APPLICATION NO.	FILING DATE	FIRST NAMED INVENTOR	ATTORNEY DOCKET NO.	CONFIRMATION NO.
10/656,259	09/08/2003	Wen-Han Hsieh	SUND 477	8609

## Office Action Summary

**DETAILED ACTION**

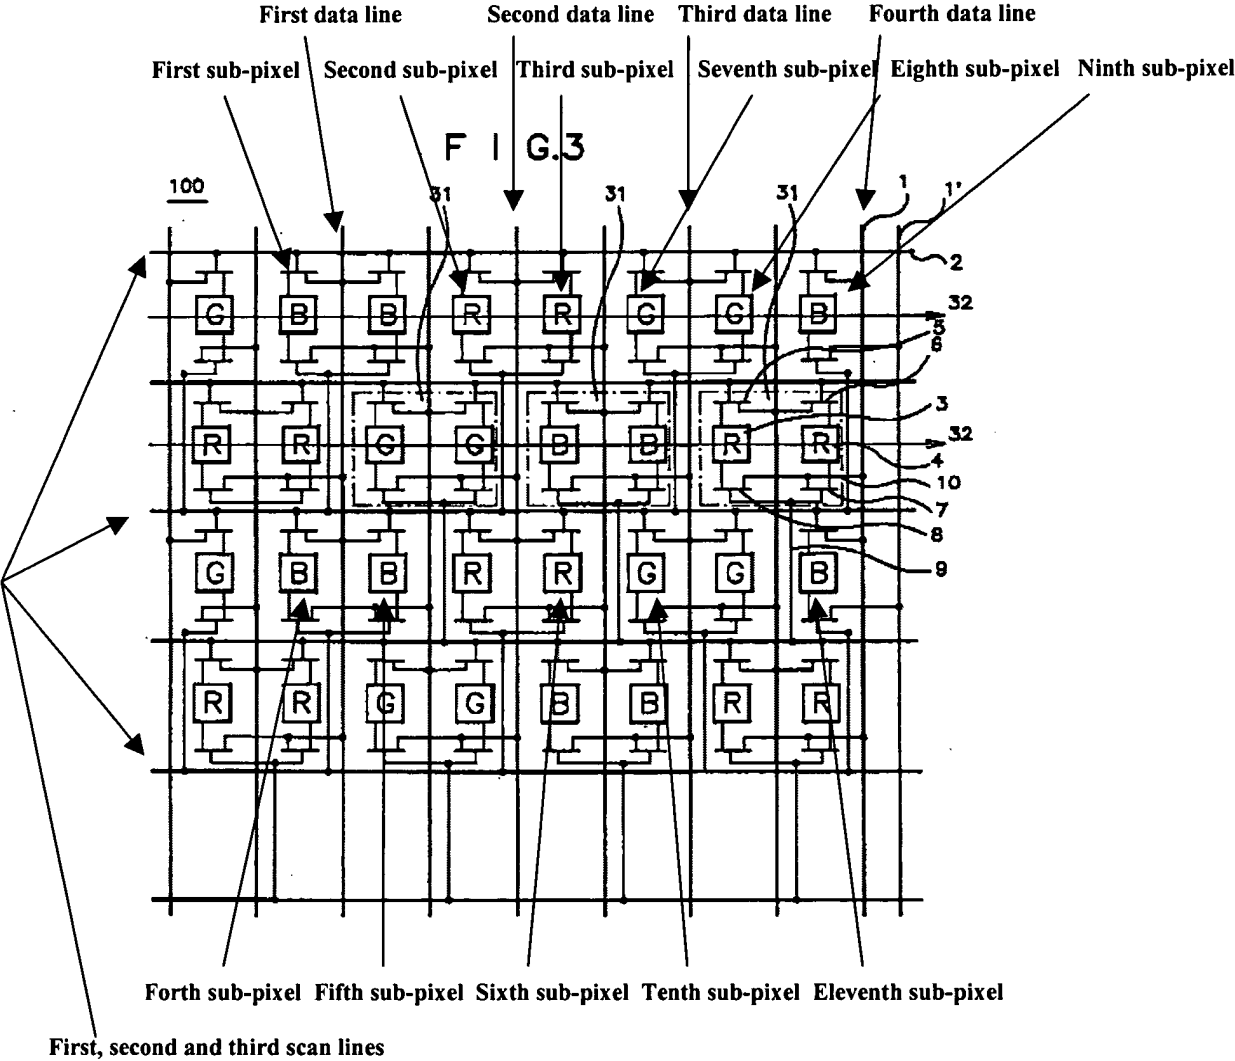
Referring to claim 1, Orgurstov et al. discloses a device comprising a first data line and a second data line, both of which being arranged substantially in parallel (Fig. 3, ref. 1); a first scan line, a second scan line, and a third scan line, all of which being arranged substantially in parallel and arranged in a matrix pattern together with the first data line and the second data line (Fig. 3, ref. 2); a first pixel comprising a first sub-pixel coupled to the first data line and the first scan line; a second sub-pixel coupled to the second data line and the first scan line; and a third sub-pixel coupled to the second data line and the second scan line; and a second pixel comprising a fourth sub-pixel coupled to the first data line and the second scan line; a fifth sub-pixel coupled to the first data line and the third scan line; and a sixth sub-pixel coupled to the second data line and the third scan line (see figure below), wherein when the first scan line is enabled, data on the first data line is input to the first sub-pixel and data on the second data line is input to the fourth sub-pixel; and when the third scan line is enabled, data on the first data line is input to the fifth sub-pixel and data on the second data line is input to the sixth sub-pixel (col. 5, lines 9-34; col. 7, lines 3-56).

Referring to claim 2, Ogurstov et al. discloses a device wherein the liquid crystal display is formed by repeatedly arranging the unit in a matrix pattern (Fig. 3).

Referring to claim 3, Orgurstov et al. discloses a device comprising a first data line, a second data line, a third data line, and a fourth data line, all of which being arranged substantially in parallel with each other (Fig. 3, ref. 1); a first scan line, a second scan line, and a third scan line, all of which being arranged substantially in parallel with each other and arranged in a matrix pattern together with the first data line, the second data line, the third data line, and the fourth data line (Fig. 3, ref. 2); a first pixel comprising: a first sub-pixel coupled to the first data line and the first scan line; a second sub-pixel coupled to the second data line and the first scan line, and a third sub-pixel coupled to the second data line and the second scan line; a second pixel comprising a fourth sub-pixel coupled to the first data line and the second scan line; a fifth sub-pixel coupled to the first data line and the third scan line; and a sixth sub-pixel coupled to the second data line and the third scan line; a third pixel comprising a seventh sub-pixel coupled to the third data line and the second scan line; an eighth sub-pixel coupled to the third data line and the first scan line; and a ninth sub-pixel coupled to the fourth data line and the first scan line; and a fourth pixel comprising: a tenth sub-pixel coupled to the third data line and the third scan line; an eleventh sub-pixel coupled to the fourth data line and the third scan line (see figure above);

wherein when the first scan line is enabled, data on the first data line is input to the first sub-pixel, data on the second data line is input to the second sub-pixel, data on the third data line is input to the eighth sub-pixel, and data on the fourth data line is input to the ninth sub-pixel; when the second scan line is enabled, data on the second data line is input to the third sub-pixel, data on the first data line is input to the fourth sub-pixel, data on the third data line is input to the seventh sub-pixel, and data on the fourth data line is input to the twelfth sub-pixel; and when the third scan line is enabled, data on the first data line is input to the fifth sub-pixel, data on the second data line is input to the sixth sub-pixel, data on the third data line is input to the tenth sub-pixel, and data on the fourth data line is input to the eleventh sub-pixel (col. 5, lines 9-34; col. 7, lines 3-56). However, the reference does not disclose that a twelfth sub-pixel is coupled to the fourth data line and the second scan line.

It would have been obvious to one having ordinary skill in the art at the time the invention was made to employ a twelfth sub-pixel is coupled to the fourth data line and the second scan line since although the reference does not show the twelfth sub-pixel, one having ordinary skill in the art at the time the invention was made would have known to include the twelfth sub-pixel following the eleventh sub-pixel in order to provide a full display. Figure 3 is a representation of a only a portion of the pixels of an entire display. As disclosed by Ogurstov et al. the illustration shown in Figure 3 is a plan view of only "a part of a liquid crystal display" (col. 4, lines 47-48). Therefore, one having routine skill in the art would have expected at least an extra column of pixels on the right side of the figure. As can be clearly seen from pattern of figure 3, each blue sub-pixel is adjacent to another blue sub-pixel. Therefore, since the reference states that the figure is only a part of a liquid crystal display, one would expect that another blue

sub-pixel would be situated to the right of the eleventh sub-pixel. Furthermore, as can be seen from the fourth sub-pixel and the fifth sub-pixel, both sub-pixels are connected to the first data line and second scan line. Therefore, following such a pattern, one having routine skill in the art would have expected that a twelfth sub-pixel situated to the right of the eleventh sub-pixel would be connected to the fourth data line and the second scan line. One having routine skill in the art would know that LCD's generally follow a consistent pattern, allowing consistency across the full display. Even though Figure 3 only shows a portion of the display, one would have reasonably expected that the rest of the display would follow the same pattern.

Referring to claim 4, Ogurstov et al. disclose the device wherein the liquid crystal display is formed by repeatedly arranging the unit in a matrix pattern (Fig. 3).
